# Access Compliance Report

### (Curb Ramps)

Intersection ID: 11256	Main Street: 5TH_ST	Cross Street: IRWIN_RD	Location: S
ADA ID: CEA089F67912	Ramp Type: Perp	Initial Pass/Fail: Fail	Overall Compliance: No
Severity Score: 25			
Codes/Mitigation Info/Possible Solution		Field Measurements/Component Compliance

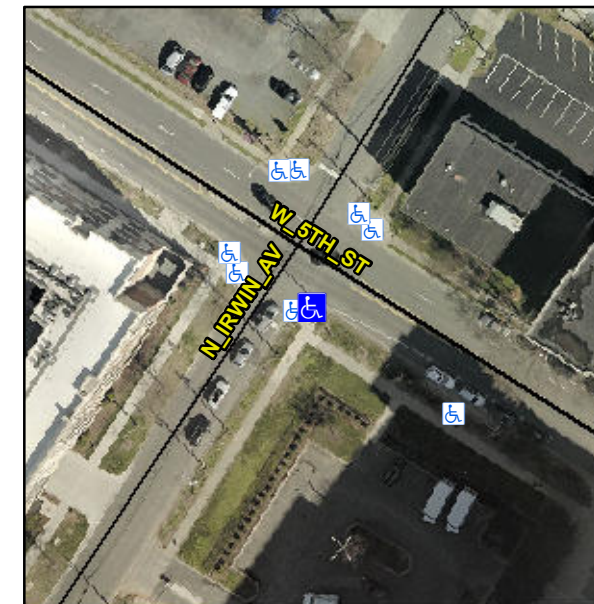
**Remove & Replace Entire Ramp.**

**R304.2.2, R304.5.3**

Compliance	Description	Data	Compliance	Description	Data
N/A	Ramp Length (in)	55.0	No	Ramp Slope (%)	9.5
Yes	Ramp Width (in)	60.0	No	Ramp XSlope (%)	5.7
N/A	Flare Type LT	N/A	N/A	Flare Type RT	N/A
N/A	Flare Slope LT (%)	N/A	N/A	Flare Slope RT (%)	N/A
N/A	Flare Traversable LT?	N/A	N/A	Flare Traversable RT?	N/A
N/A	Landing Length (in)	N/A	N/A	DWS Provided?	N/A
N/A	Landing Width (in)	N/A	N/A	DWS Contrast?	N/A
N/A	Landing Slope (%)	N/A	N/A	DWS Length (in)	N/A
N/A	Landing X Slope (%)	N/A	N/A	DWS Full Width?	N/A
N/A	Landing Curb? (Y/N)	N/A	N/A	DWS Offset (in)	N/A
N/A	Shared Landing?	N/A			
N/A	Gutter Ponding?	N/A	N/A	Gutter Slope (%)	N/A
N/A	Gutter Lip Ht (in)	N/A	N/A	Gutter X Slope (%)	N/A
N/A	Painted X Walk1?	No	N/A	Painted X Walk2?	N/A
	X Walk 1 Direction	To NE		X Walk 2 Direction	N/A
N/A	X Walk 1 Width (in)	N/A	N/A	X Walk 2 Width (in)	N/A
	X Walk 1 Slope (%)	4.9		X Walk 2 Slope (%)	N/A
	X Walk 1 X Slope (%)	2.6		X Walk 2 X Slope (%)	N/A
